From: Allen Gleckner [AGleckner@elpc.org]
Sent: Wednesday, January 11, 2012 5:37 PM
To: Fermi3COLEIS Resource
Subject: NRC-2008-0566; NUREG-2105 comments
Attachments: Fermi 3 DEIS Comments Final _1-11-12.pdf

Attached please find comments from the Environmental Law & Policy Center and the Michigan Environmental Council on Detroit Edison's COL application Draft Environmental Impact Statement.

Re: Draft Environmental Impact Statement for Combined License (COL) for Enrico Fermi Unit 3, NUREG-2105, Docket No. NRC-2008-0566

Figure 1. Karst areas identified in Monroe County, MI (Source: SEMCOG, 2010)

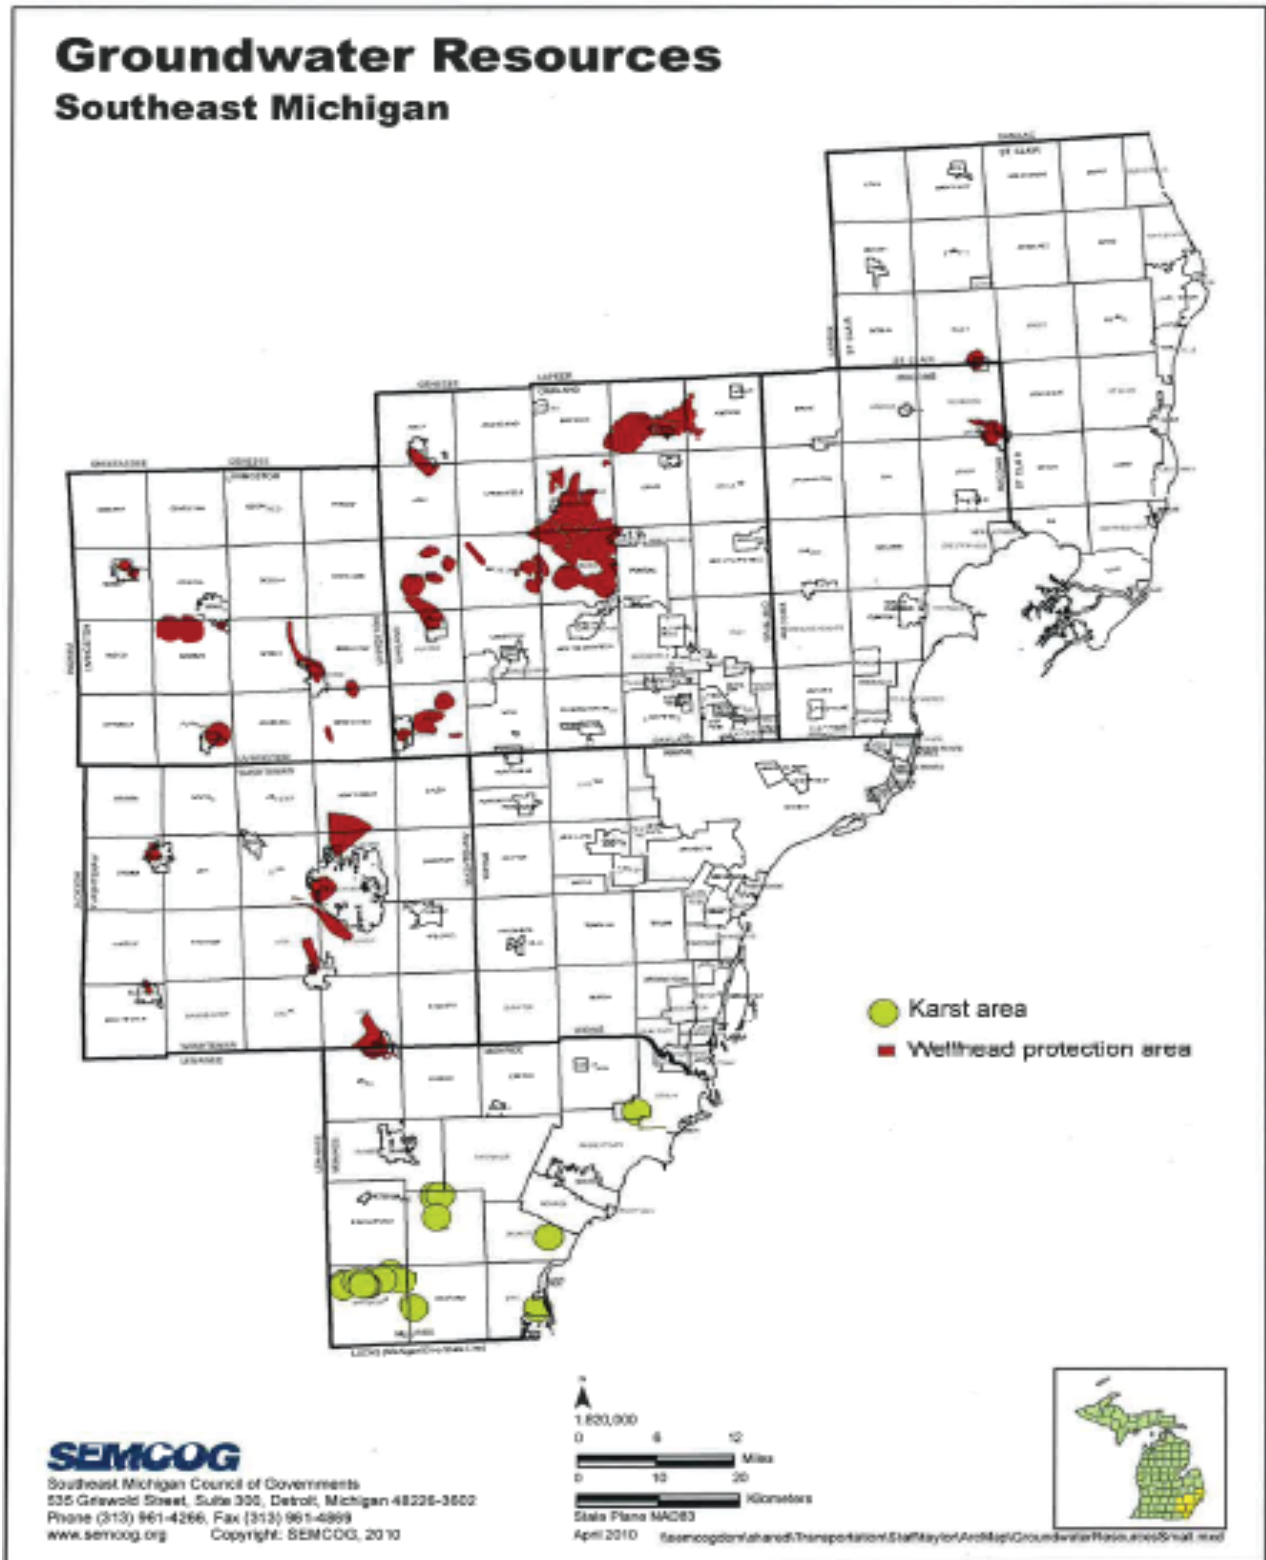
B. Karst Geology Is Not Sufficiently Characterized At The Fermi Site.

Section 2.5.3.8.2 of the FSAR claims that “the potential for nontectonic deformation at the Fermi 3 site is negligible,” and that “there is no evidence of nontectonic deformation at the Fermi 3 site in the form of unloading phenomenon (i.e., pop-up features), glacially-induced faulting, salt migration, dissolution or collapse related to karst, or volcanic intrusion.” But Figure 1 (below), which identifies several known Karst areas in Monroe County, Michigan where the Fermi site is located, demonstrates that a more thorough search for this type of subsurface formation in the area is warranted. Two concerns related to this issue include:

- Risk of future subsidence at the site that could damage the structural integrity of the reactor containment building, existing or potential radioactive waste storage facilities, and other important structures.
- Risk of contamination of groundwater beyond the Fermi site via unknown flow pathways that are typically inherent in Karst formations even where obvious underground voids are not identified through bore sampling and other techniques.

More evaluation of these risks is necessary to reduce the uncertainty raised by the existence of multiple Karst formations so near to the proposed project site as shown in Figure 1.
